Application Number: 10/824,915
Filing Date: April 15, 2004
Appellant(s): SELLE, STEPHEN

EXAMINER'S ANSWER

► Claims 1 and 3-11 stand rejected under 35 U.S.C. 103(a) as being obvious over Applicant's admission of prior art, in view of either Selle US-6,640,968 or Liestner US-6,209,722.

Examiner's reasonably broad interpretation of Applicant's admitted prior art.

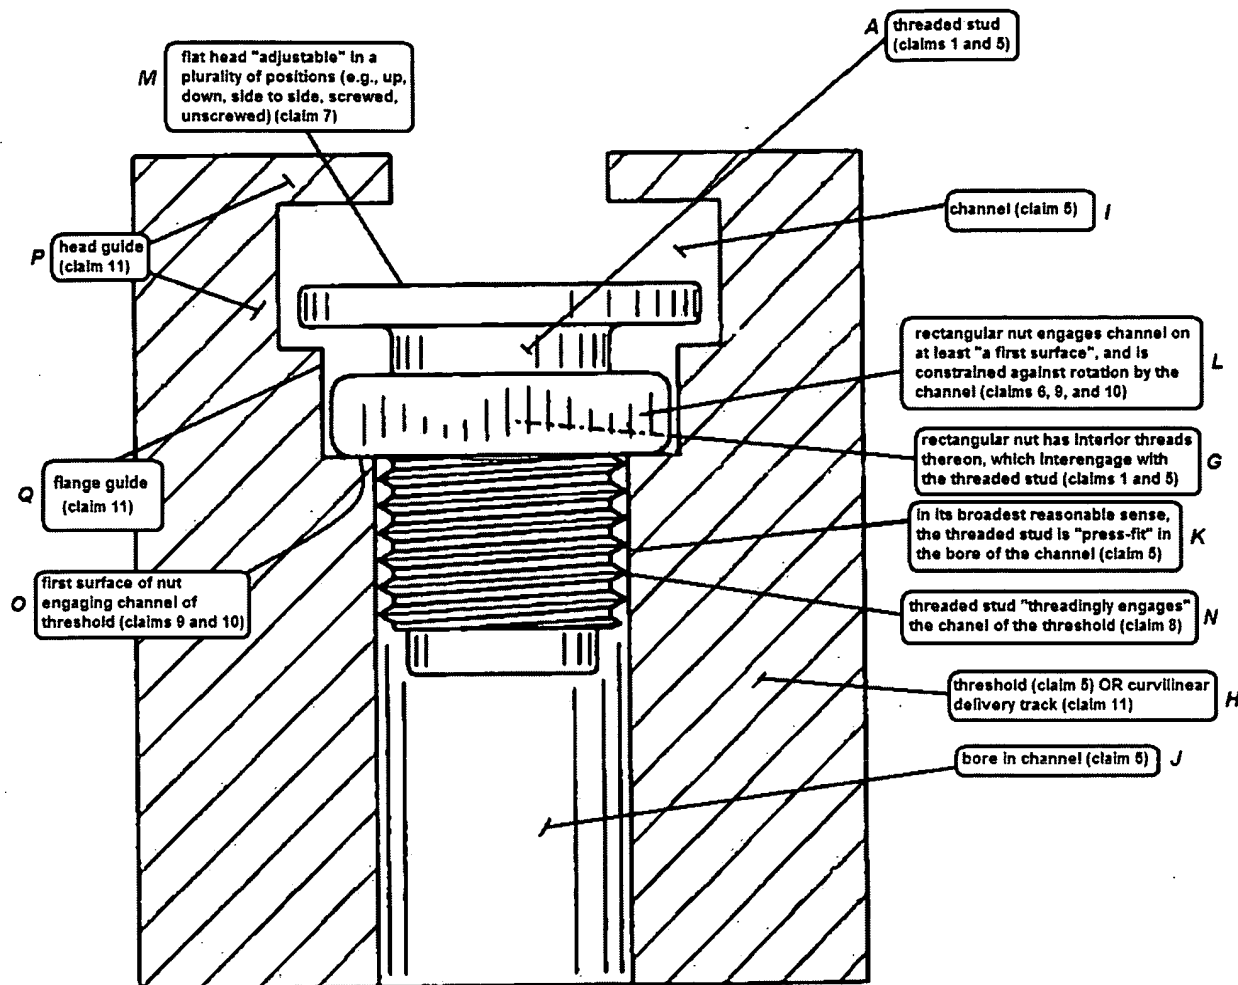
In short, and when the claims are given their broadest reasonable interpretation, Applicant substantially discloses a prior art fastener/threshold adjustment device comprising each and every limitation found in claims 1 and 3-11, **with the exception of raised flanges** located at first and second ends of the nut. Applicant alleges that these flanges are advantageous, because they serve to prevent jamming (i.e., "shingling") within a curvilinear delivery track (also known in the art as a "feed" or "feeding" track, a "magazine", or a "hopper").

As for claim 1, Applicant discloses as prior art, a fastener comprising a threaded stud (A), a rectangularly-shaped nut (B) having first (C) and second (D) ends, said threaded stud (A) interengaging said rectangularly-shaped nut (B).

As for claim 4, Applicant discloses as prior art, a threaded stud including first (E) and second (F) adjustment receptacles.

As for claim 5, Applicant discloses as prior art, a threshold adjustment device comprising a threaded stud (A), an adjustment receptacle (E,F), a rectangularly shaped nut (B), said threaded stud interengaging said nut (G), a threshold (H) having a channel (I), said channel including a bore (J) therein, said threaded stud being press-fit (K) in said bore (J). Applicant also admits on page 3, line 4 of the specification that it is known to "press-fit" a prior art fastener into a threshold.

As for claim 6, Applicant discloses as prior art, a nut (B) being constrained against rotation (L) by said channel (I).

As for claim 7, Applicant discloses as prior art, a flat head (M), which is adjustable in a plurality of positions.

As for claim 8, Applicant discloses as prior art, a threaded stud (A) threadingly engaging (N) the channel (I) of the threshold (H).

As for claim 9, Applicant discloses as prior art, the nut (B) having a first surface (O) and said first surface (O) of said nut (B) engages the channel (I) of the threshold (H).

As for claim 10, Applicant discloses as prior art, the nut (B) includes a first surface (O) and said first surface (O) of said nut (B) engages the channel (I) of the threshold (H).

Selle US-6,640,968

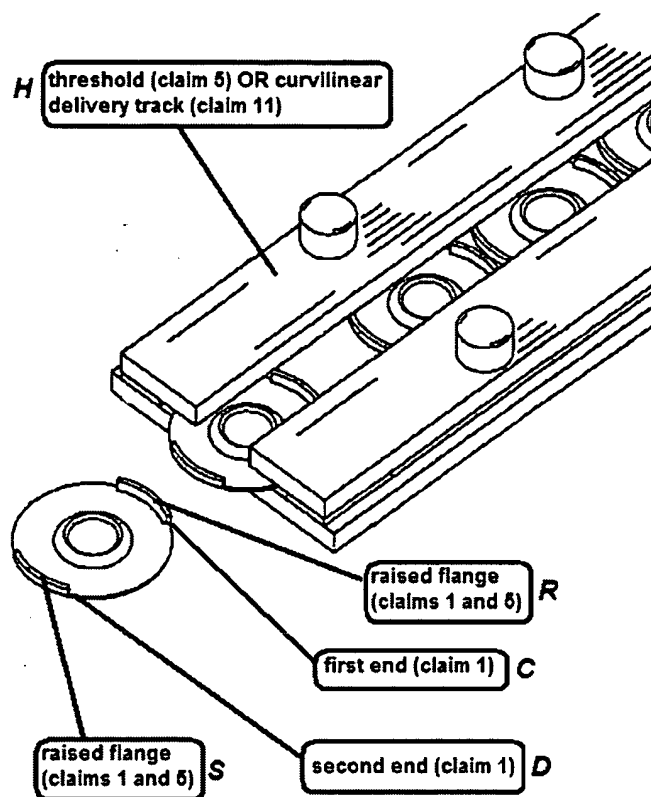
Selle US-6,640,968 suggests employing **raised flanges** (R, S) on first (C) and second (D) ends of a fastener element, so that when said fastener element is placed within a curvilinear

delivery track (H), said raised flanges (R,S) prevent shingling or jamming within said curvilinear delivery track (H). Refer to Selle US-6,640,968, column 1 lines 49-52 and column 3 lines 56-58.

Therefore, at the time of invention, it would have been obvious to those having an ordinary skill in the art, to modify the prior art rectangular nut (B) disclosed in Applicant's admission of the prior art, by employing raised flanges (R, S) on first (C) and second (D) ends of said rectangular nut (B) as suggested by Selle US-6,640,968, in order to prevent shingling or jamming of said rectangular nut (B) when disposed within a threshold (H) or a curvilinear delivery track (H).

Liestner US-6,209,722

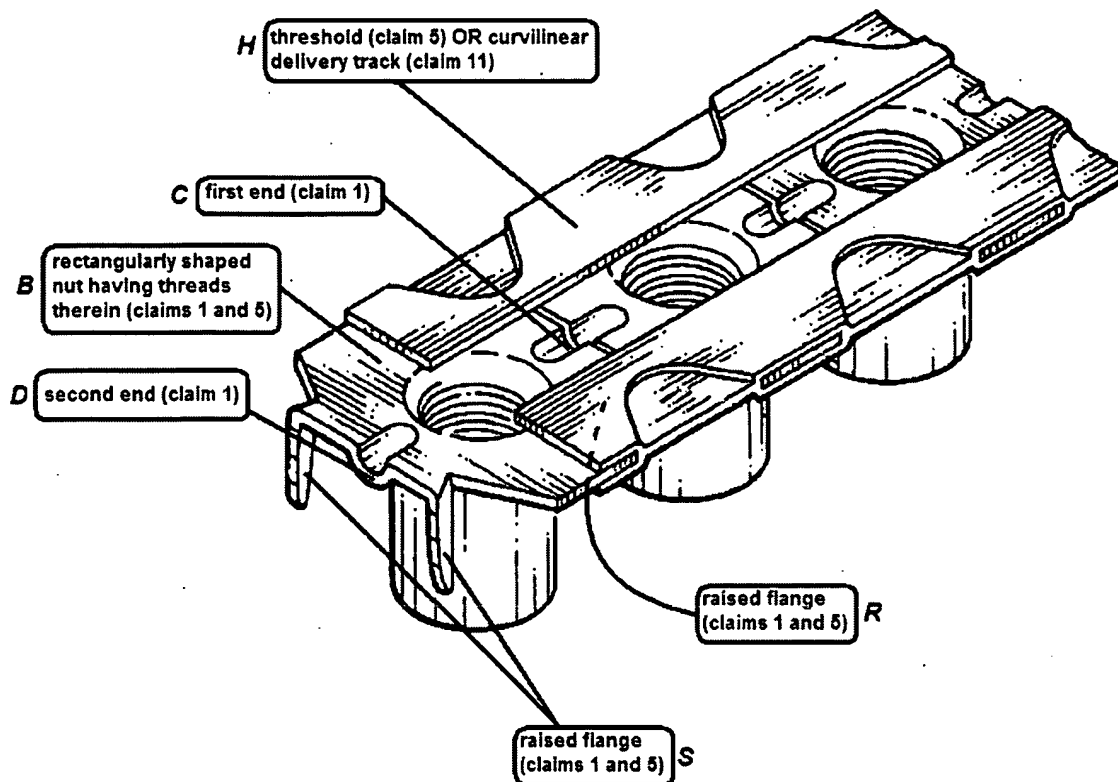
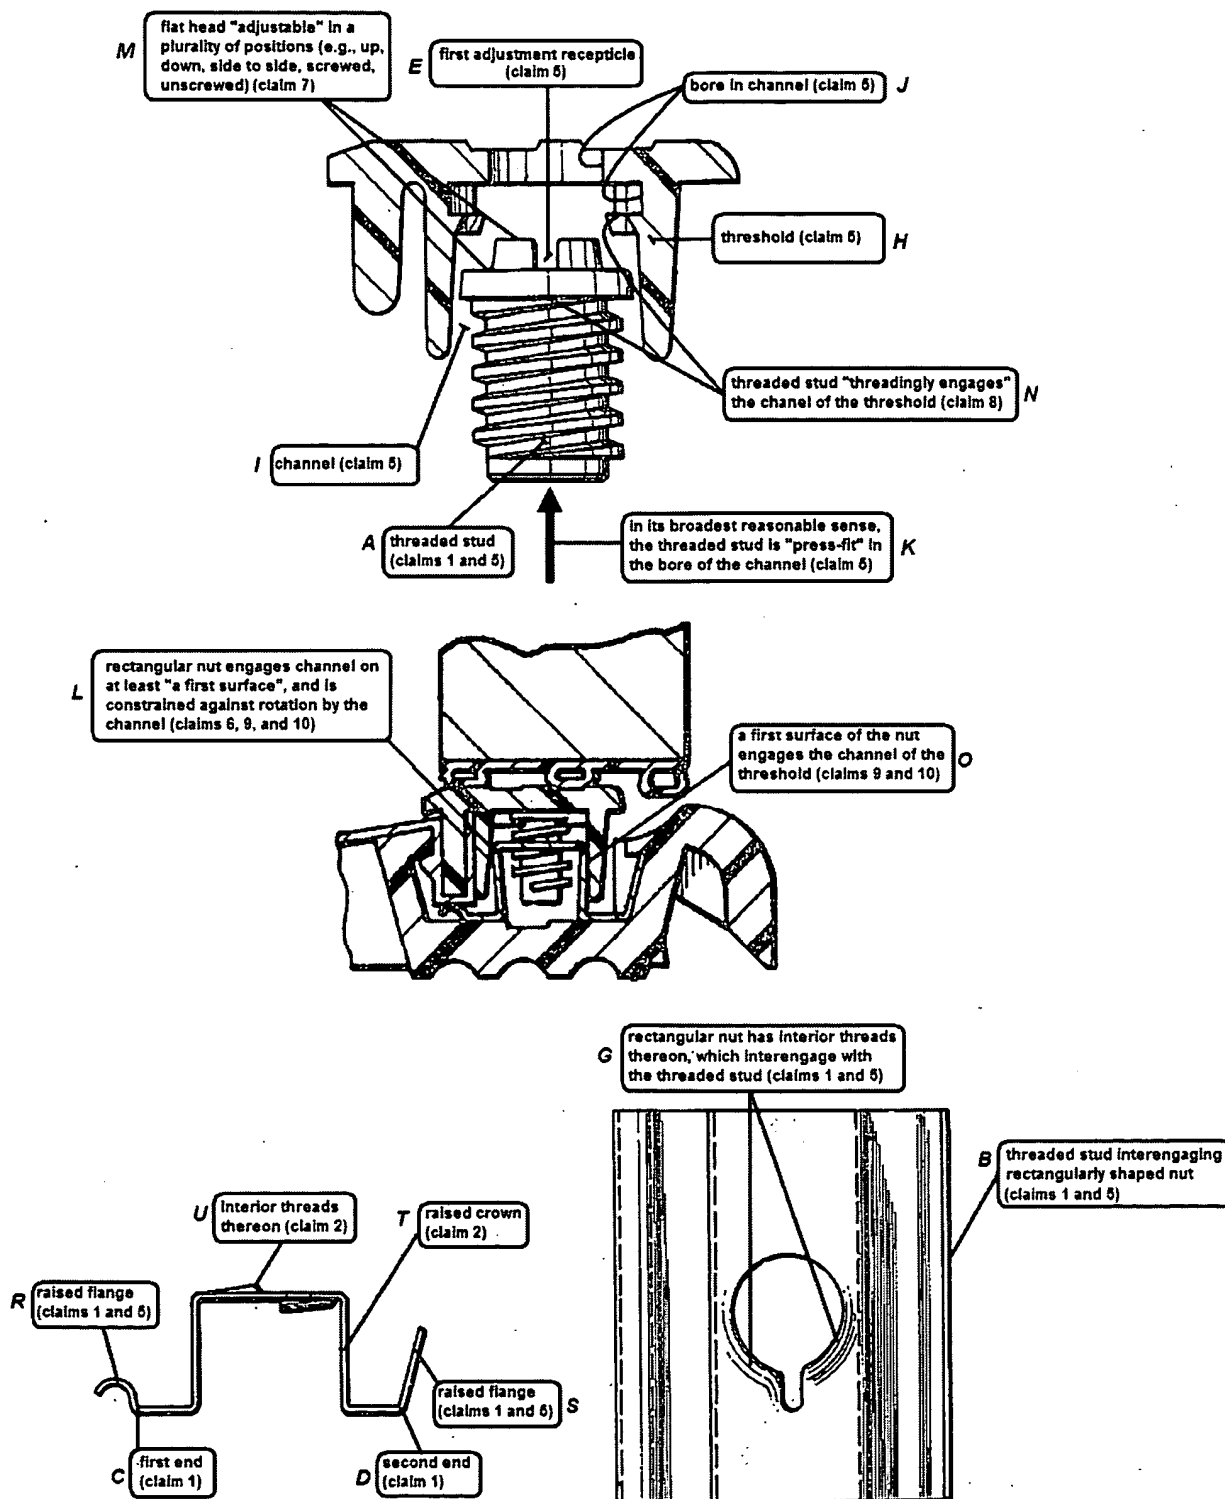
Liestner US-6,209,722 suggests employing **raised flanges** (R,S) on first (C) and second (D) ends of a rectangular nut (B), so that when said nut (B) is placed within a curvilinear

delivery track (H), said raised flanges (R,S) prevent shingling or jamming of said nut (B) within said curvilinear delivery track (H).

Therefore, at the time of invention, it would have been obvious to those having an ordinary skill in the art, to modify the prior art rectangular nut (B) disclosed in Applicant's admission of the prior art, by employing raised flanges (R, S) on first (C) and second (D) ends of said rectangular nut (B) as suggested by Liestner US-6,209,722, in order to prevent shingling or jamming of said rectangular nut (B) when disposed within a threshold (H) or a curvilinear delivery track (H).

Examiner's reasonably broad interpretation of Bursk et al. US-4,352,258.

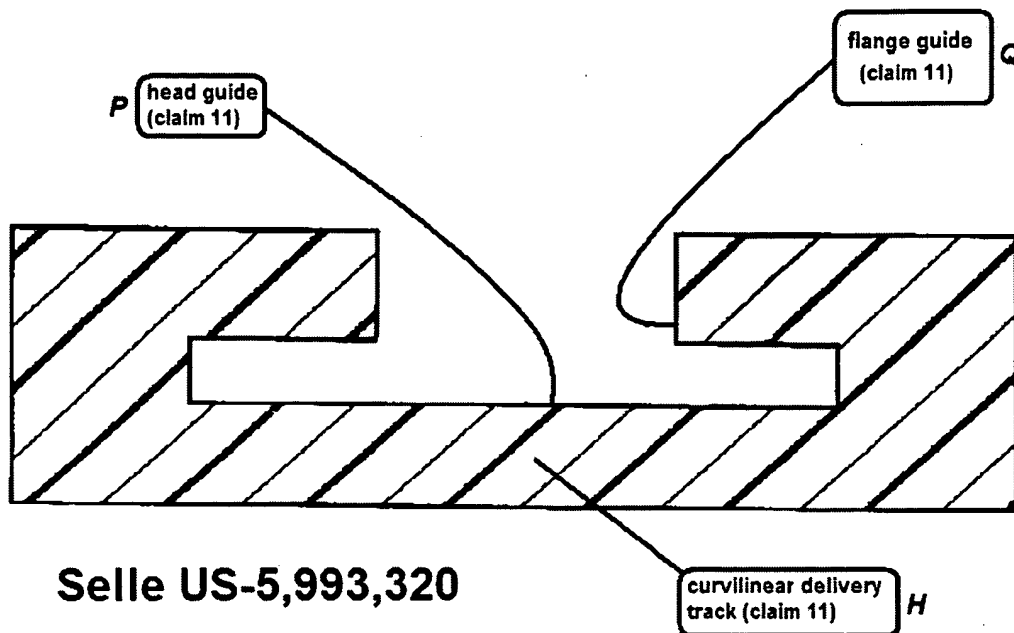
In short, and when the claims are given their broadest reasonable interpretation, the Bursk et al. reference substantially discloses a prior art fastener/threshold adjustment device comprising each and every limitation found in claims 1-3 and 5-11.

As for claim 1, the Bursk et al. reference discloses a fastener comprising a threaded stud (A), a rectangularly-shaped nut (B) having first (C) and second (D) ends each having a raised flange (R,S), said threaded stud (A) interengaging said rectangularly-shaped nut (B).

As for claim 2, the Bursk et al. reference discloses said rectangularly-shaped nut (B) includes a raised crown (T) having interior threads (U) thereon.

As for claim 3, the Bursk et al. reference discloses said raised flanges (R, S) extending upwardly partially enveloping said threaded stud (A).

As for claim 5, the Bursk et al. reference discloses a threshold adjustment device comprising a threaded stud (A), an adjustment receptacle (E), a rectangularly shaped nut.(B), said threaded stud interengaging said nut (G), a threshold (H) having a channel (I), said channel including a bore (J) therein, said threaded stud being press-fit (K) in said bore (J).

As for claim 6, the Bursk et al. reference discloses a nut (B) being constrained against rotation (L) by said channel (I).

As for claim 7, the Bursk et al. reference discloses a flat head (M), which is adjustable in a plurality of positions.

As for claim 8, the Bursk et al. reference discloses a threaded stud (A) threadingly engaging (N) the channel (I) of the threshold (H).

As for claim 9, the Bursk et al. reference discloses the nut (B) having a first surface (O) and said first surface (O) of said nut (B) engages the channel (I) of the threshold (H).

As for claim 10, the Bursk et al. reference discloses the nut (B) includes a first surface (O) and said first surface (O) of said nut (B) engages the channel (I) of the threshold (H).

Examiner's reasonably broad interpretation of Selle US-5,993,320.

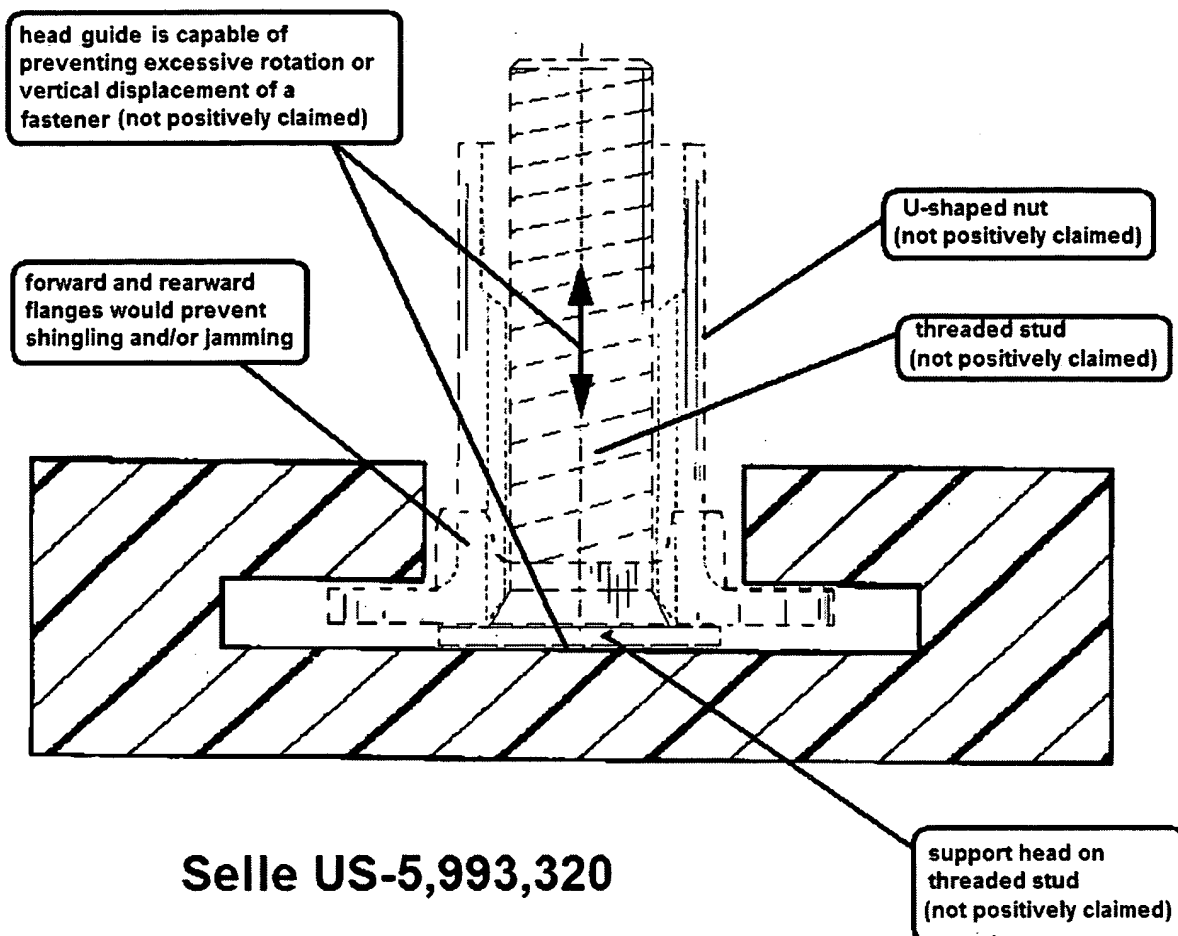
In short, and when claim 11 is given its broadest reasonable interpretation, the Selle reference discloses as prior art, a curvilinear delivery track (H) for delivering a plurality of fasteners, said delivery track (H) includes a head guide (P) and a flange guide (Q). Examiner notes that there appears to be no clear antecedent basis for the limitation "said head guides" (plural emphasis added) on line 5 of claim 11. Examiner further notes that claim 11 has been interpreted as not positively reciting "fasteners", since the preamble only positively recites that the intended use of the curvilinear delivery track is for delivering a plurality of fasteners (emphasis added). The word "for" merely signifies an intended use of the positively recited curvilinear track. Since it is believed by the examiner that no fasteners are positively claimed, the structural and function recitations directed to said fasteners are not given significant patentable merit since they only modify an intended use of the curvilinear delivery track.

Although the plurality of fasteners including a U-shaped nut and a threaded stud are not positively recited in claim 11, it is important to illustrate that the curvilinear delivery track disclosed by the Selle reference is inherently capable of performing the claimed intended use recitations, in order to satisfy the requirements of 35 U.S.C. 102. Accordingly, the examiner has clearly illustrated the capabilities of the curvilinear track disclosed by Selle below (dashed lines are examiner's sketch and are for illustrative purposes only):

Examiner's reasonably broad interpretation of Mettler US-6,185,870

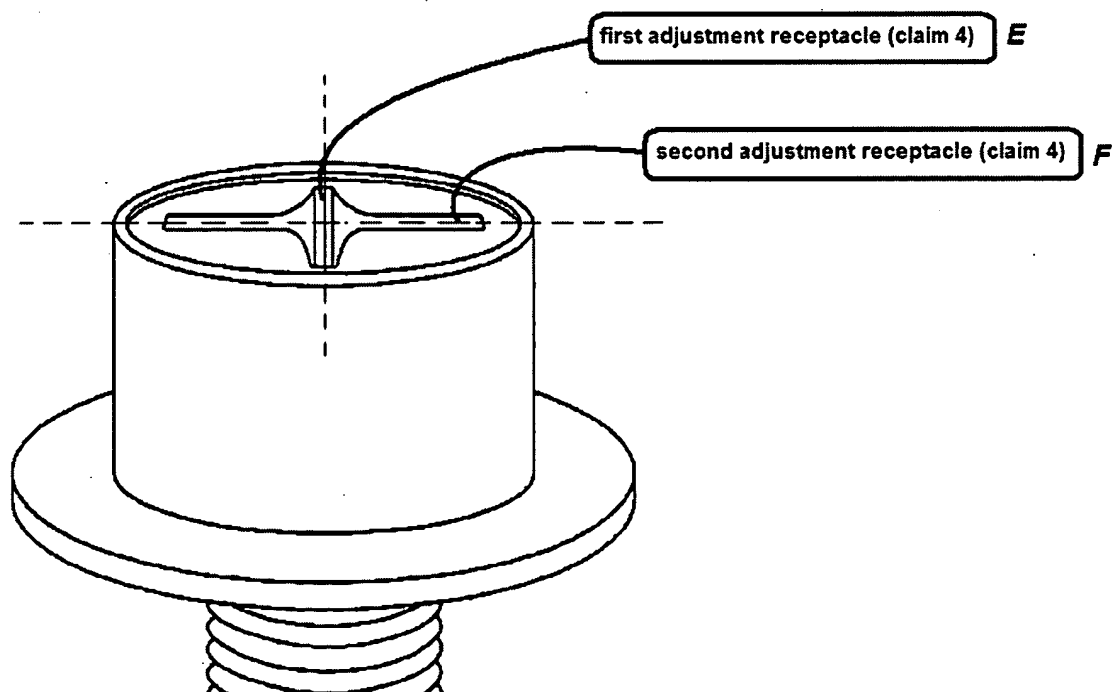
In short, and when the claims are given their broadest reasonable interpretation, the Bursk et al. reference substantially discloses a prior art fastener comprising each and every limitation found in claims 1 and 4 as described above, **with the exception of a second adjustment receptacle.**

As for claim 1, the Bursk et al. reference discloses a fastener comprising a threaded stud (A), a rectangularly-shaped nut (B) having first (C) and second (D) ends each having a raised flange (R,S), said threaded stud (A) interengaging said rectangularly-shaped nut (B).

As for claim 4, the Bursk et al. reference discloses the threaded stud (A) of the fastener having a first adjustment receptacle (E), which allows only a flat head screwdriver to enter therein.

However, as previously stated, the Bursk et al. reference fails to disclose expressly, a **second adjustment receptacle**.

Mettler US-6,185,870 suggests employing a **second adjustment receptacle (F)** to a fastener, in order to allow both a Phillips head screwdriver and a flat head screwdriver to enter therein, making it convenient to adjust said fastener, regardless of which type of screwdriver is readily available.

Therefore, at the time of invention, it would have been obvious to those having an ordinary skill in the art, to modify the fastener taught by Bursk et al., by further employing a **second adjustment receptacle** as suggested by Mettler, in order to provide the fastener with the ability to be adjusted by both a Phillips head screwdriver and a flat head screwdriver.

Examiner's reasonably broad interpretation of Bursk et al. US-4,352,258.

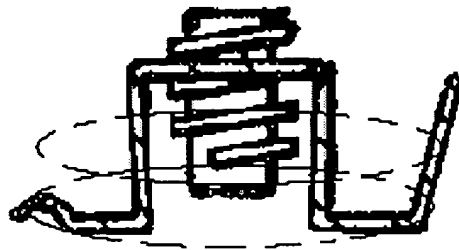
Applicant's argument that the Bursk et al. reference fails to show a crown is not persuasive. As clearly illustrated in the above rejection, the rectangularly-shaped nut disclosed by Bursk et al. has a raised crown (T) having interior threads (U) thereon.

Examiner's reasonably broad interpretation of Bursk et al. US-4,352,258.

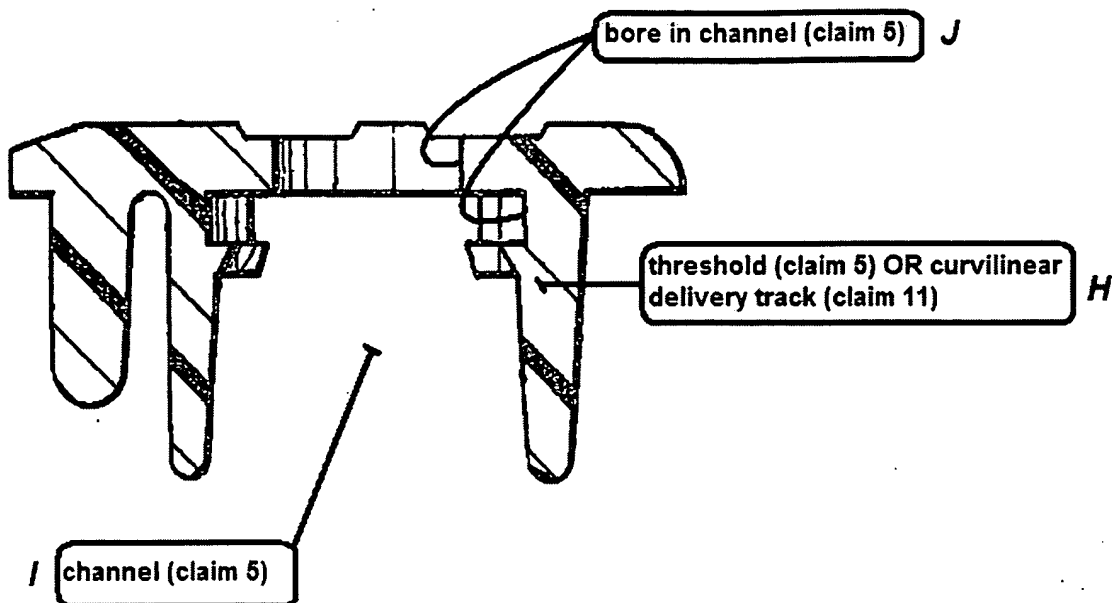
Applicant's allegation that parts 85 and 88 of the rectangularly-shaped nut taught by Bursk et al. are not raised flanges, and do not in any way envelope or surround the stud is acknowledged; however, Examiner feels that in its broadest reasonable interpretation, Bursk et al. does show raised flanges which broadly "envelope" or "surround" the threaded stud.

Examiner's reasonably broad interpretation of Bursk et al. US-4,352,258.

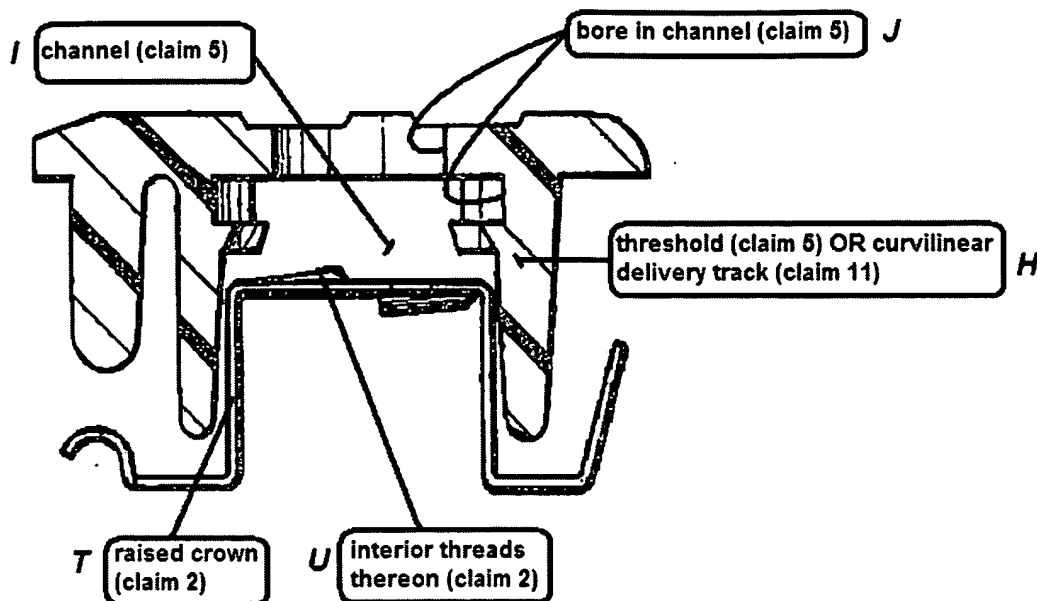
In response to Applicant's argument that the threaded stud 60 taught by Bursk et al. is not "press-fit" into the bore of the channel, Bursk et al. clearly shows that the threaded stud 60 must be forced upwardly into a bore in the channel in order to be secured thereto.

In response to Applicant's argument that the examiner has not shown the bounds or the extent of the channel is irrelevant. Applicant merely claims a (broad) "channel", and gives no such limitation to the "bounds or extent of the channel". In order for Bursk et al. to anticipate claim 5, Bursk et al. must show a channel (I) in a threshold (H), said channel (I) having a bore (J) therein. Examiner has clearly demonstrated that Bursk et al. discloses these limitations.
